SUNDRY NOTICES AND REPORTS ON WELLS (DO NOT USE THIS FORM FOR PROPOSALS TO DRILL OR TO DEEPEN OR PLUG BACK TO A DIFFERENT RESERVOIR. USE "APPLICATION FOR PERMIT" (FORM C-101) FOR SUCH PROPOSALS.)		WELL API NO. 30-045-38312

2. Name of Operator SIMCOE LLC		6. State Oil & Gas Lease No. NMNM03358
3. Address of Operator 1199 MAIN AVE., STE #101, DURANGO, CO 81301		7. Lease Name or Unit Agreement Name NORTHEAST BLANCO UNIT

13. Describe proposed or completed operations. (Clearly state all pertinent details, and give pertinent dates, including estimated date of starting any proposed work). SEE RULE 19.15.7.14 NMAC. For Multiple Completions: Attach wellbore diagram of proposed completion or recompletion.  
 SIMCOE LLC is requesting to extend the Surface Casing to 3,601' TVD.

Sundry ID: 2750470

## Wellbore Schematic

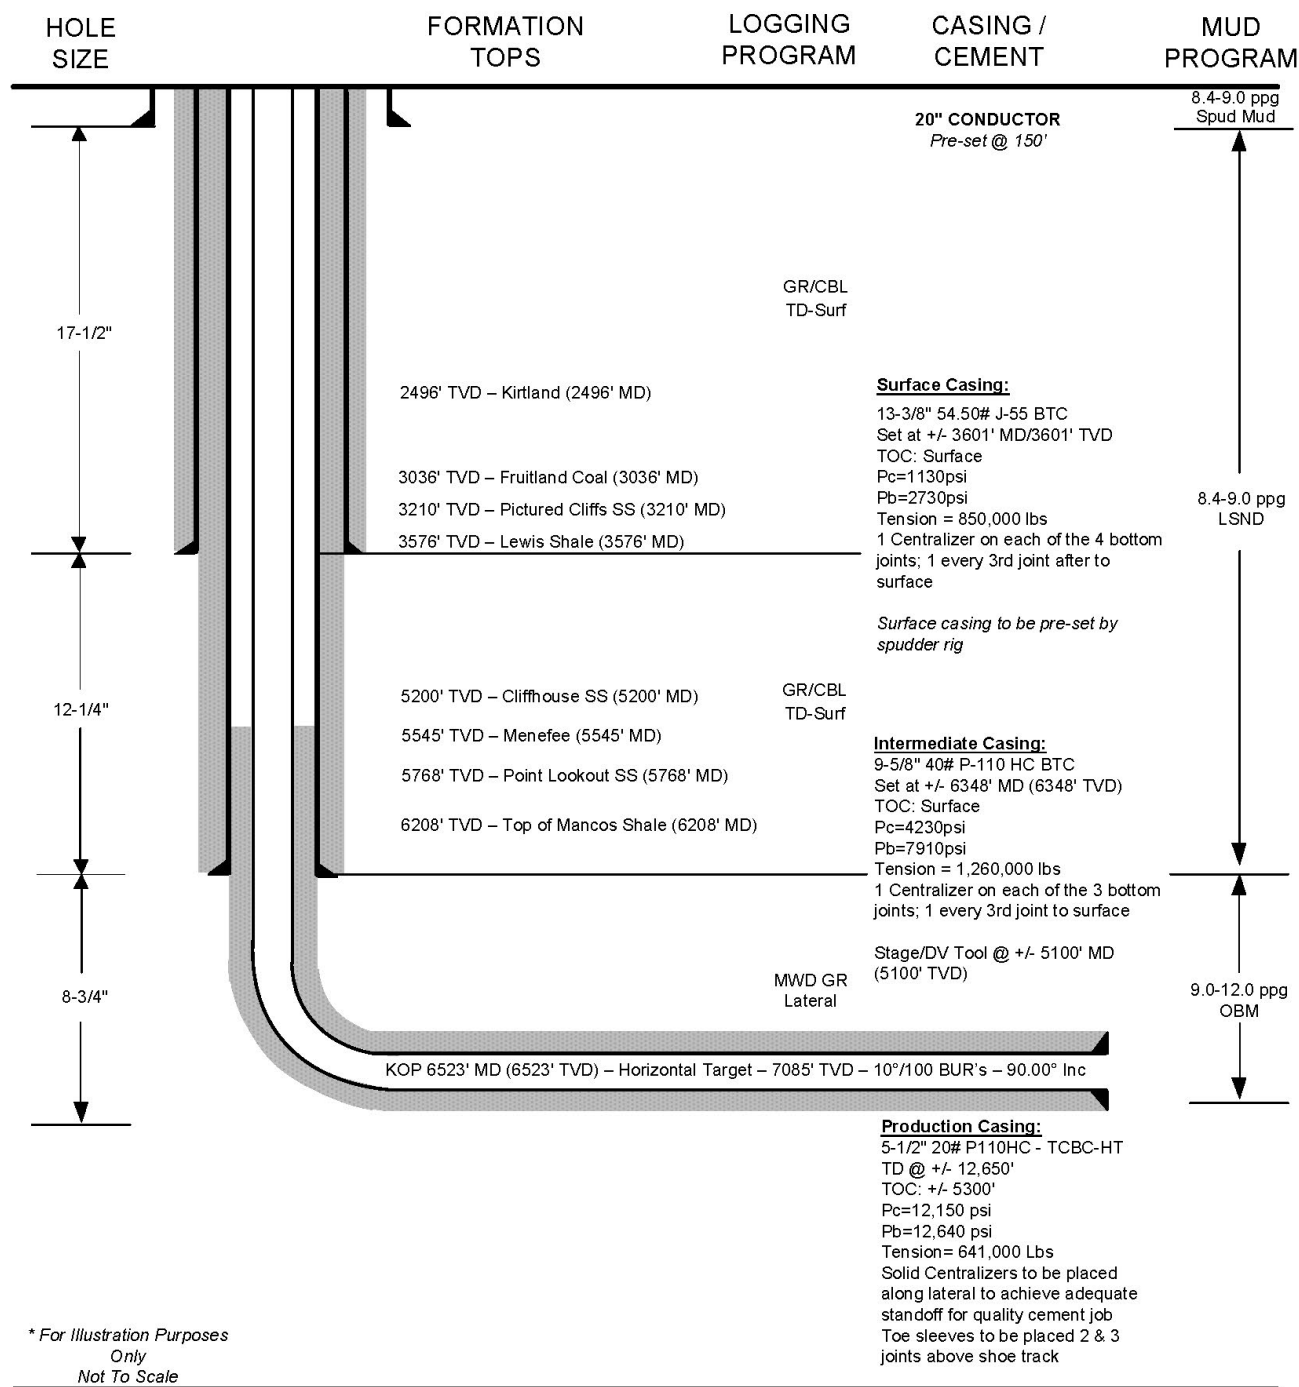
Current Surface Casing Program (as approved in the APD):  
 Casing size 13-3/8" set at ±1100' TVD; conventional cement job (1 stage), circulated to surface.

Revised Surface Casing Program:  
 Casing size 13-3/8" set at ±3601' TVD (roughly 25' into the Lewis Shale); conventional cement job (1 stage), circulated to surface.

To mitigate expected lost circulation problems in previously designed long (±5500' MD), deviated intermediate casing section; extreme lost circulation encountered both in offset operator's wells in addition to historic BP NEBU wells; will allow depleted intervals in Kirtland, Fruitland Coal, & Pictured Cliffs to be isolated behind pipe (surface casing) before drilling into the known depleted intervals in the Mesa Verde section; setting surface casing deeper (into the Lewis) allows for improved drilling efficiency & also increases the safety of drilling operations through these depleted sections.

No change to the Conductor, Intermediate and Production casing from the original approved casing program. Please see attached NEBU 602-5H Updated Casing Safety Cement Program for details. The Lewis Shale is a competent, hard, and low permeability shale. Setting casing 25' into the Lewis gives us a competent casing point, allowing us to drill the intermediate section of the wellbores with minimal difficulties.

1. Surface casing must be always at a minimum half fluid fill.

Created By	Condition	Condition Date
dmcclure	Fresh water-based mud shall be used when drilling the hole for the surface casing.	10/11/2023
dmcclure	If cement does not circulate for the surface casing, Simcoe shall do the following; (a) contact the Division's Northern Compliance Officer Supervisor and coordinate the remediation of the cement; (b) provide the Division a CBL demonstrating competent cement after the remediation of the cement; and (c) not proceed with drilling the well until approved to do so by the Division.	10/11/2023

## Wellbore Schematic

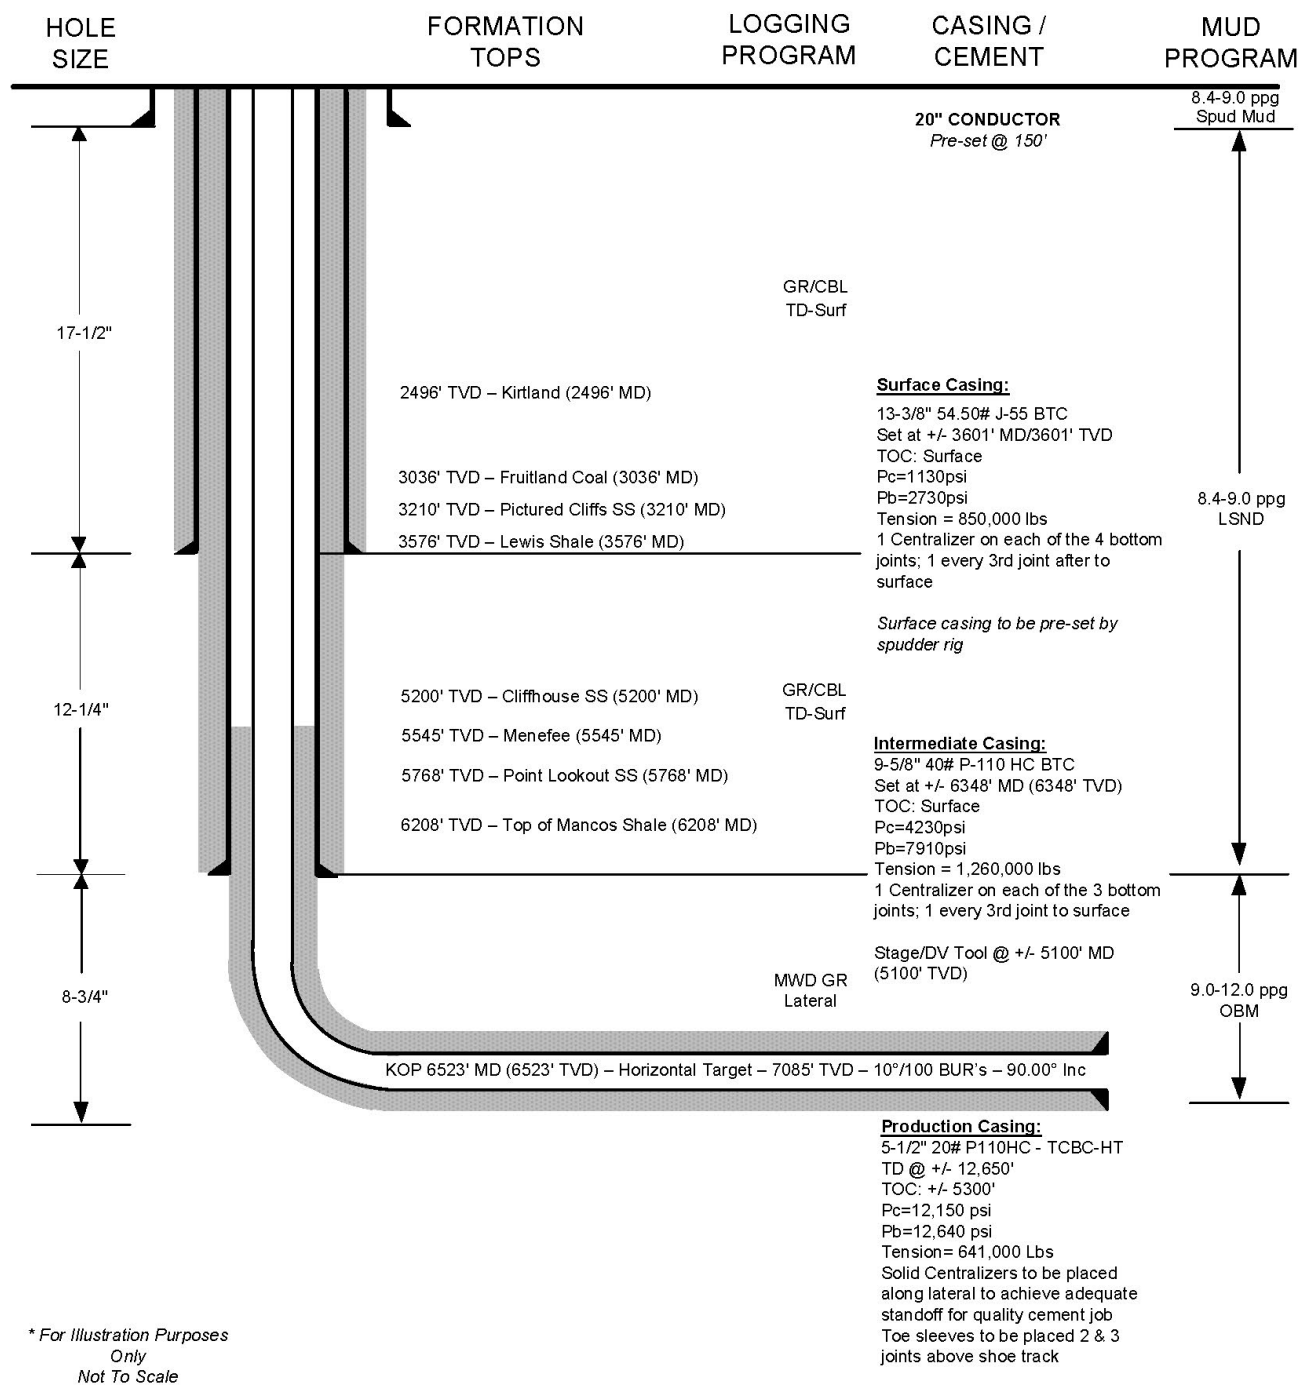
Reasons for setting deeper surface casing.

- to mitigate expected lost circulation problems in previously designed long (5500 MD), deviated intermediate casing section
- extreme lost circulation encountered both in offset operators wells in addition to historic BP NEBU wells
- will allow depleted intervals in Kirtland, Fruitland Coal, & Pictured Cliffs to be isolated behind pipe (surface casing) before drilling into the known depleted intervals in the Mesa Verde section
- setting surface casing deeper (into the Lewis) allows for improved drilling efficiency & also increases the safety of drilling operations through these depleted sections

1. Surface casing must be always at a minimum half fluid fill.
